Over Hill Wind Farm
Technical Appendix 6.2

SNH & RSPB CORRESPONDENCE

Our Ref: CNS/RENWF/EA/OH/CDM146207
Your Ref: 17/0395/PP
Date: 31 August 2017

**Erection of 11 turbines (up to 149.9m to blade tip) and associated infrastructure
Overhill Wind Farm, Dalmellington**

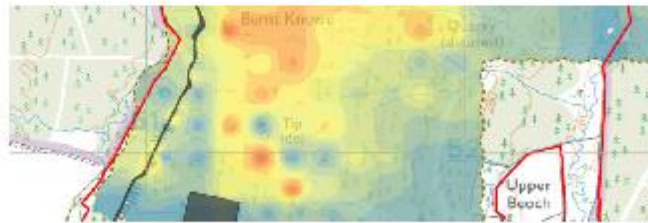
Figure 1 to this letter shows the required 1.75km noise buffer on Upper Beoch which turbines need to avoid. This buffer rules out the southern area of the site where the non-peat habitats exists.

Figure 1 to this letter details revised Habitat Management Proposals that we would like to discuss further with SNH. These comprise:

- **Management Unit A (Maintain and Enhance Existing Blanket Bog):** Management unit A has been extended to ensure that the open areas surrounding the forestry are subject to appropriate management also (an additional 49.6 ha is included in MUA).

- **Management Unit B (Forestry Removal & Restoration of Blanket Bog):** These proposals have been revised to increase the area of blanket bog to be restored by removing commercial forestry from the site. Management Unit B – Additional shows a further 57.25ha to be included in the bog restoration proposal.
